SUBJECT: CHANGE ORDER 2 - WPCF DIGESTER IMPROVEMENT PHASE II PROJECT

CHANGE ORDER NO. 2

PROJECT: Digester Improvements Phase II
 OWNER: City of Ames
 CONTRACT: 2019-017
 CONTRACTOR: Shank Constructors, Inc.

Cost Proposal Request
Digester Improvements Phase II
City of Ames, Iowa
Contract 2019-017
April 8, 2019

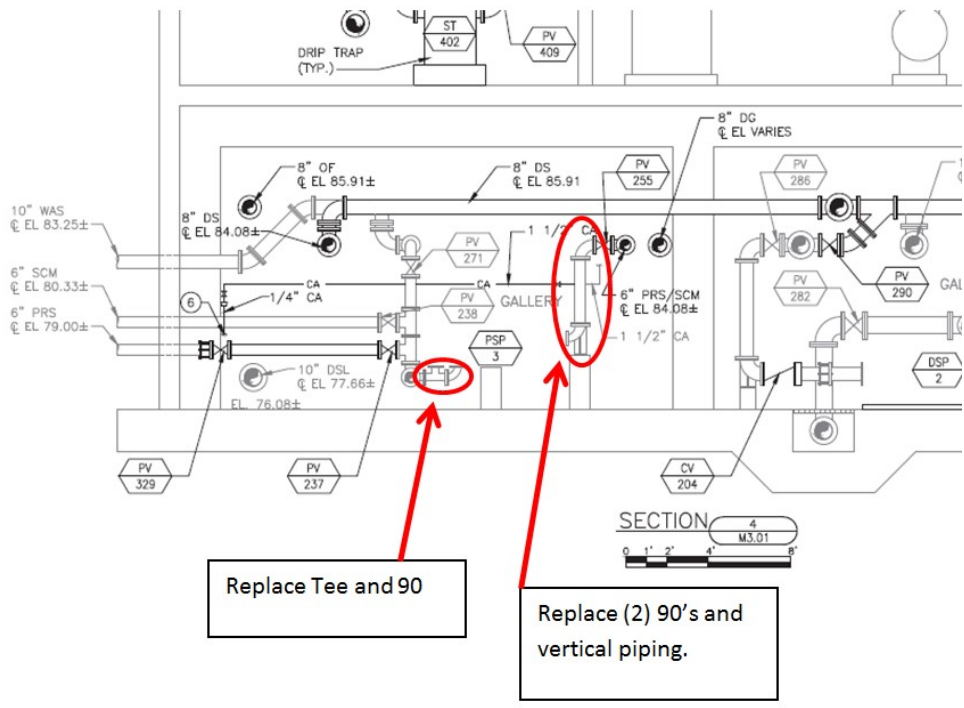
1. We would like to add replacement of the two tee's highlighted in the attached picture (Sheet 24).
2. We would like to replace the (2) 90 degree elbows on the sludge transfer line with tee's. The current elbow is shown in the attached photo.

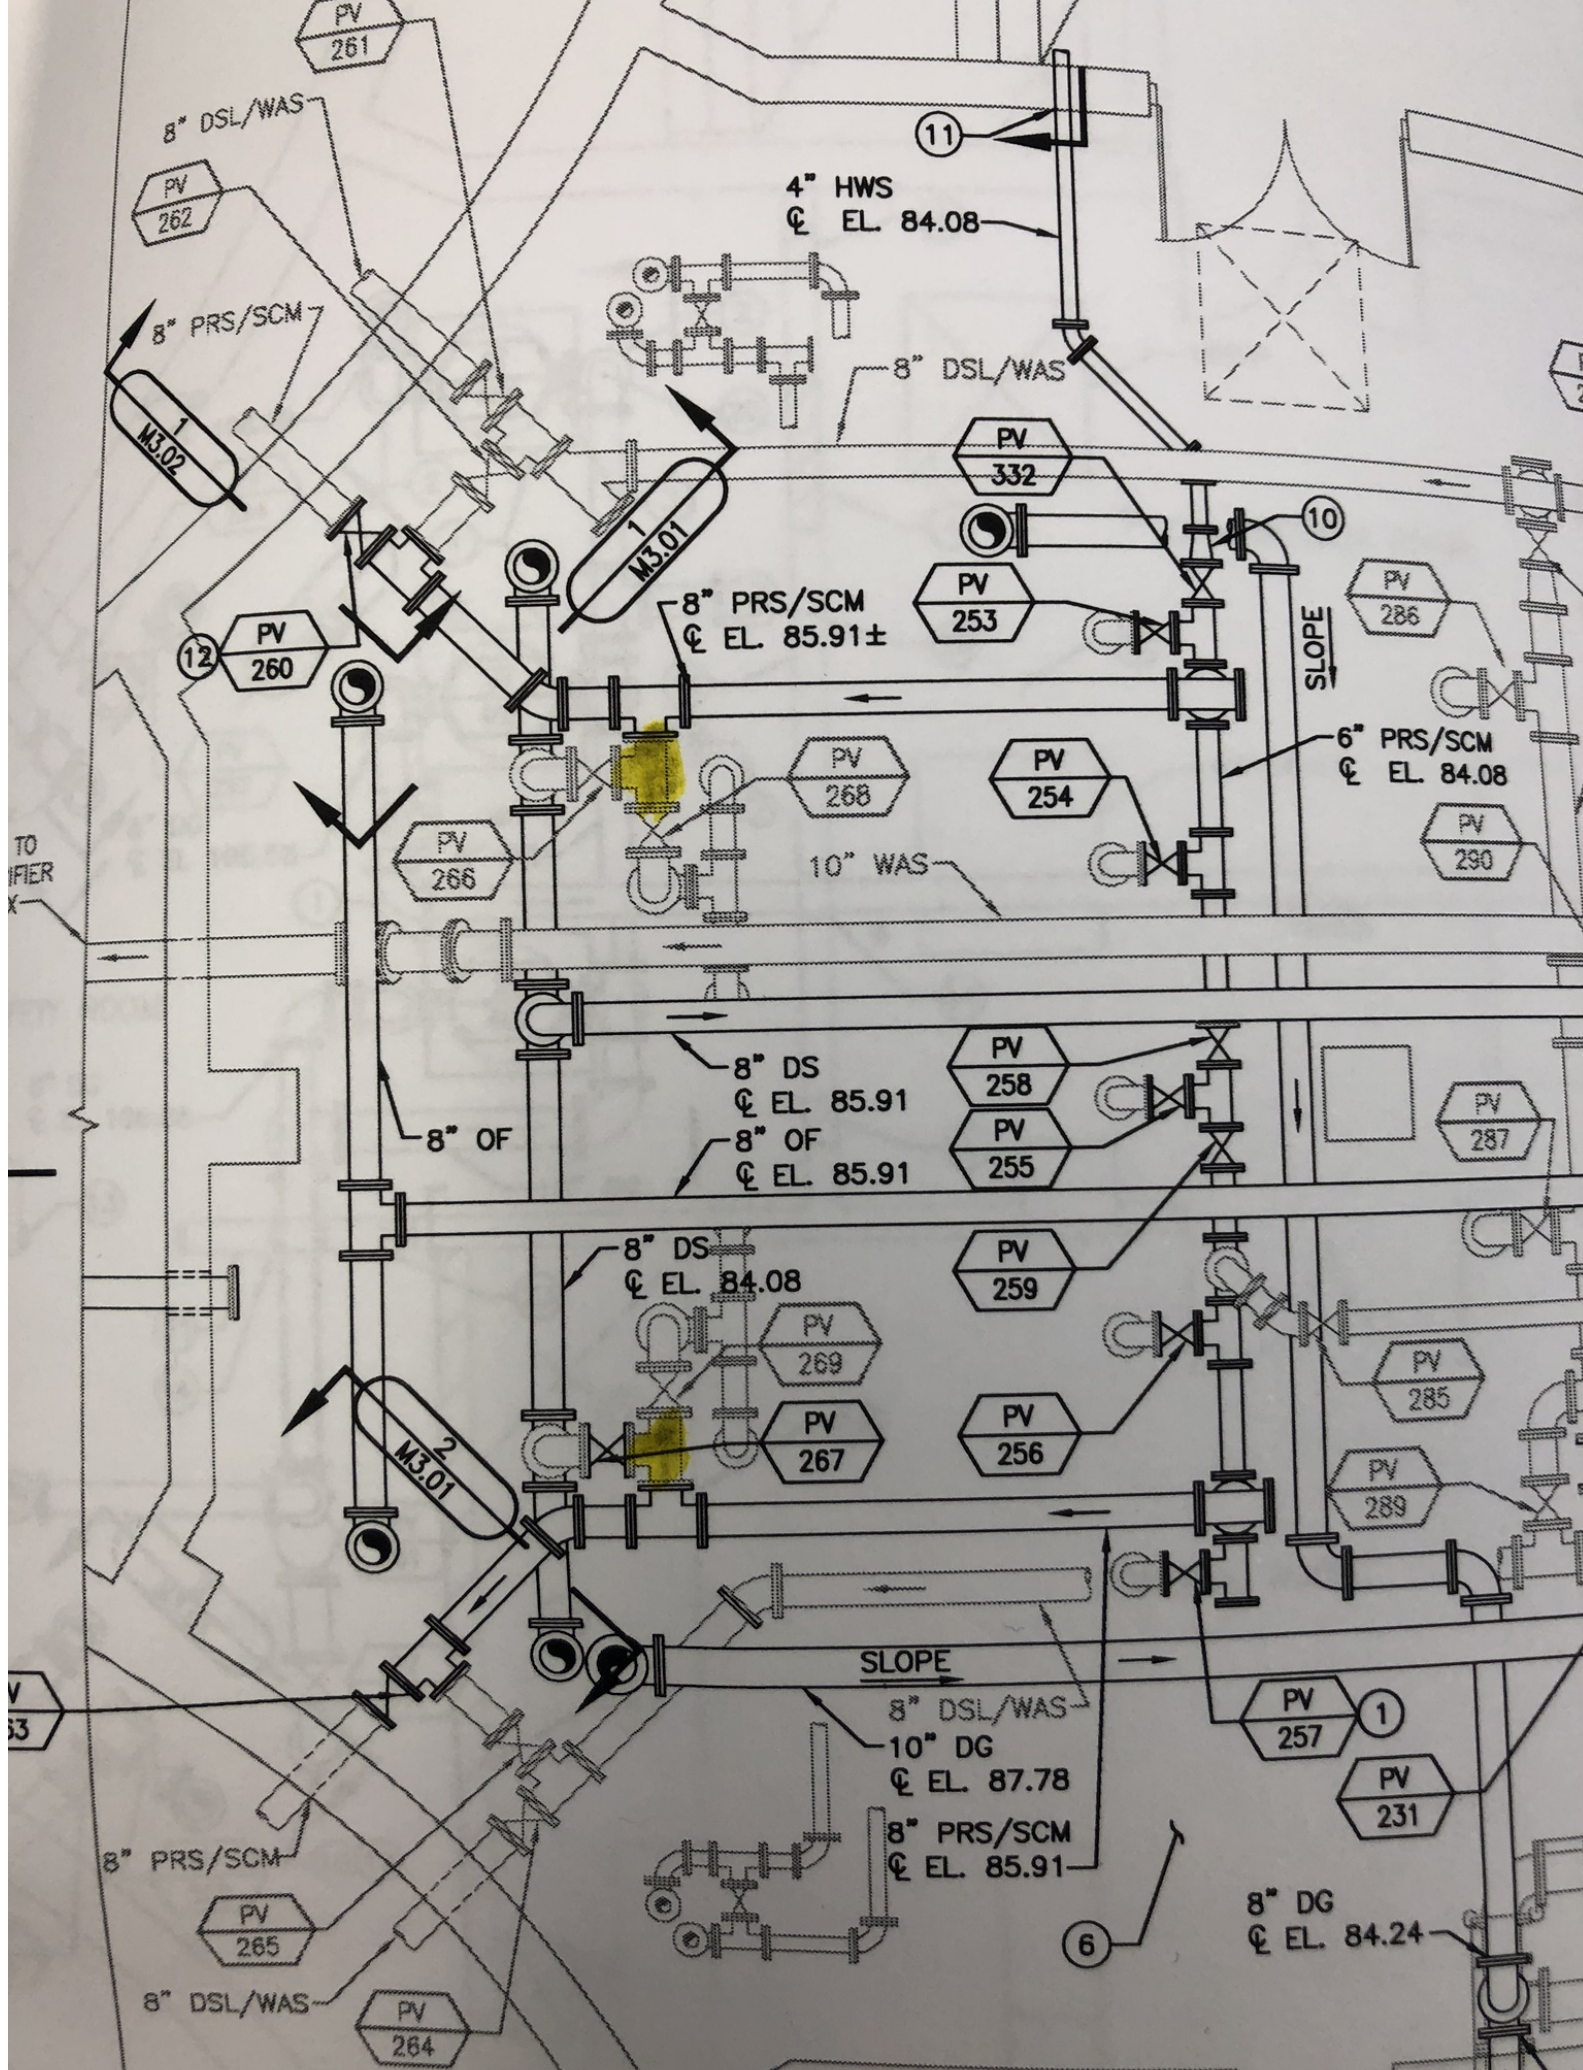
1. Sheet 28 Section 4: We would like to replace the piping circled in red below associated with each of the PSP's. The vertical pipe on the discharge side has a sample port that we would like to include with the new piping. I have included a photo in the attachments that shows the sample port.

PVC Piping called out in specs to be replaced with ductile

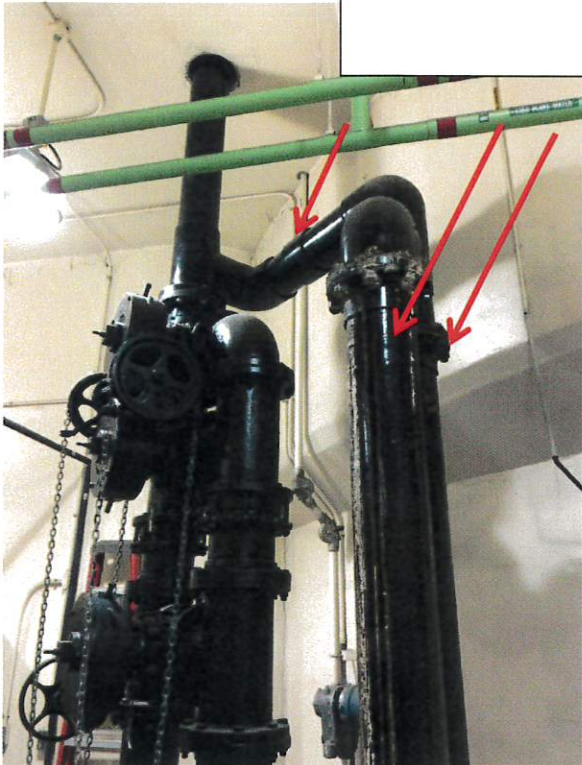
Sheet 28 Section 3: The horizontal PVC line is called out to be replaced as shown in the photo below. In order to tie back into the vertical piping, the PVC above the last ductile flange should to be replaced with ductile.

The arrows indicate existing PVC that will need to be changed out to ductile.

SHEET
8
05-CME1.01

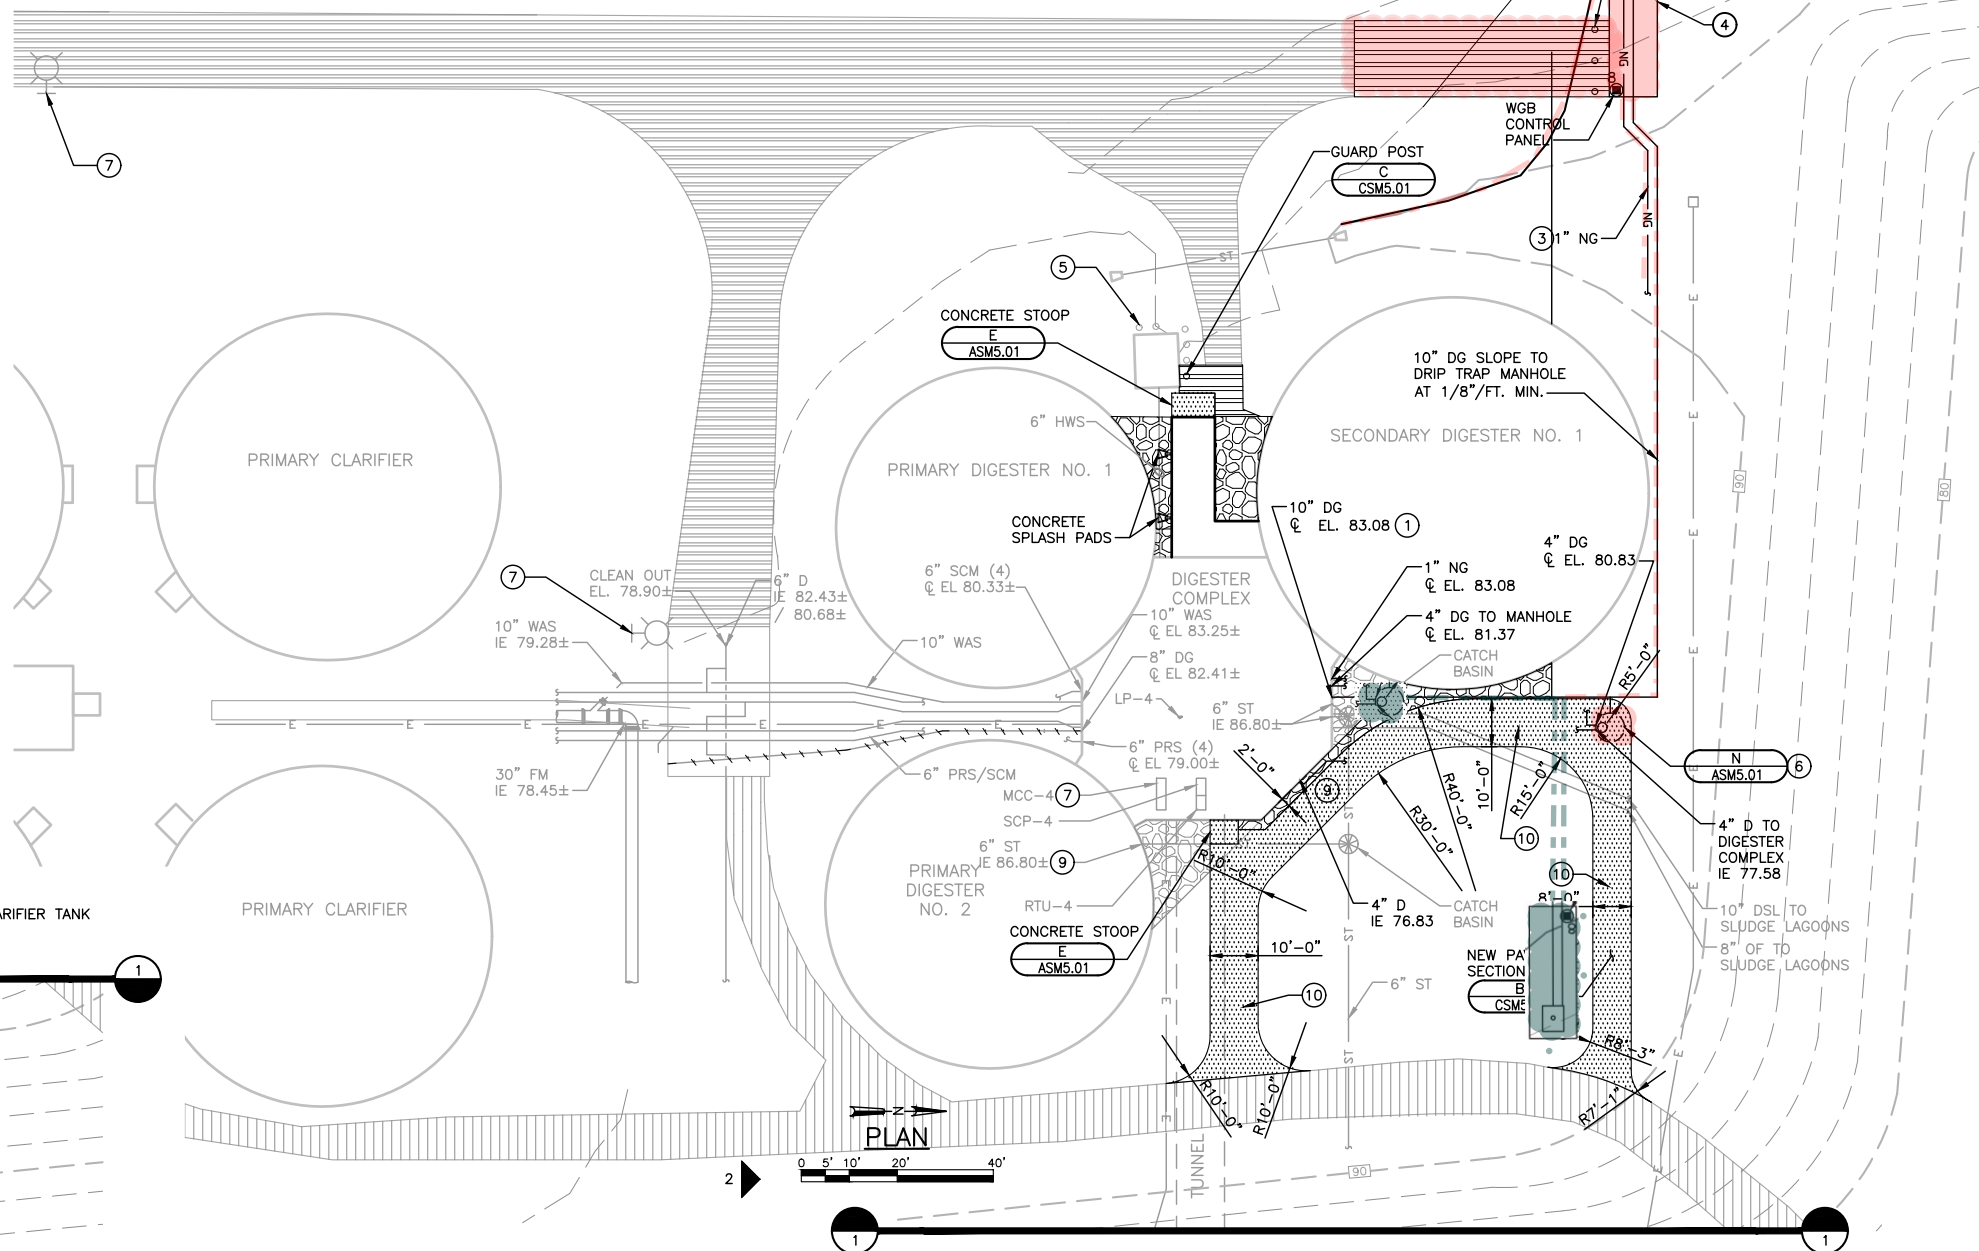
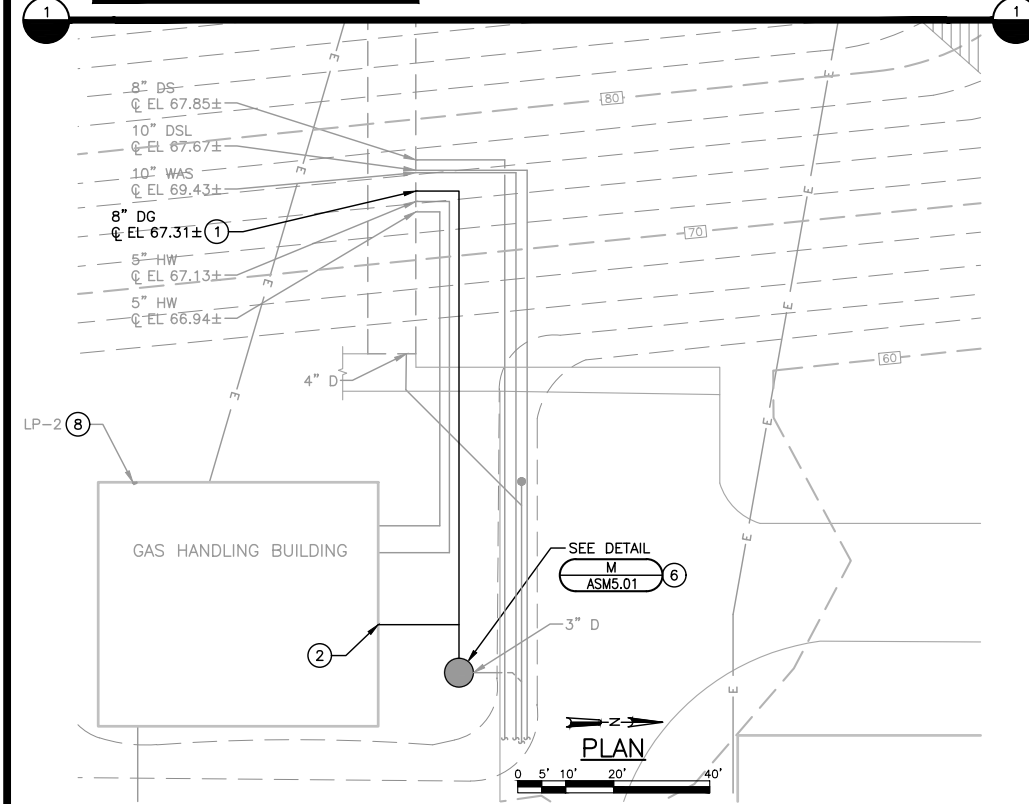
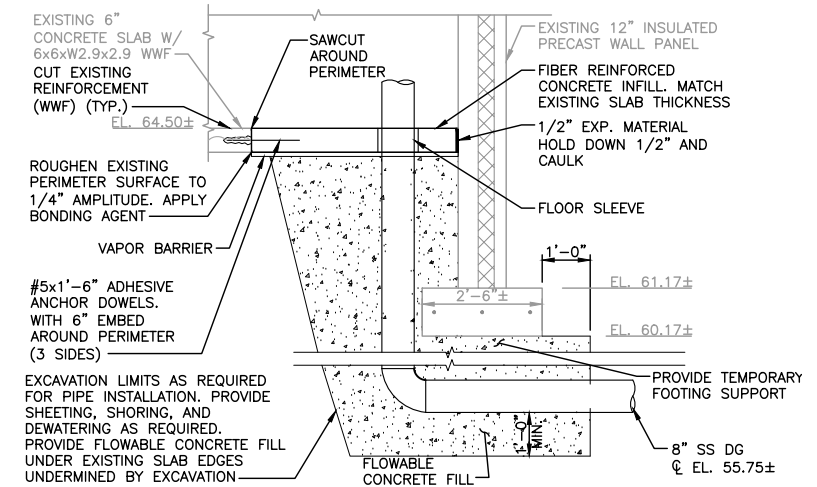
Drawing 05-CME1.01 Sheet 8

- 004-01 Move waste gas burner, equipment pad, and guard posts to location east of Secondary Digester No. 1 as shown on the enclosed drawing in green. Route NG piping and DG piping to new location. Slope DG piping minimum 1/4-inch per foot along piping route with high point at bend to waste gas burner. Elevation of waste gas burner concrete pad shall be approximately 3-inches above existing grade. Coordinate locations of guard posts with Owner.
- 004-02 Delete work associated with new gravel road near original waste gas burner location.
- 004-03 Delete work associated with grading the area around original waste gas burner location.
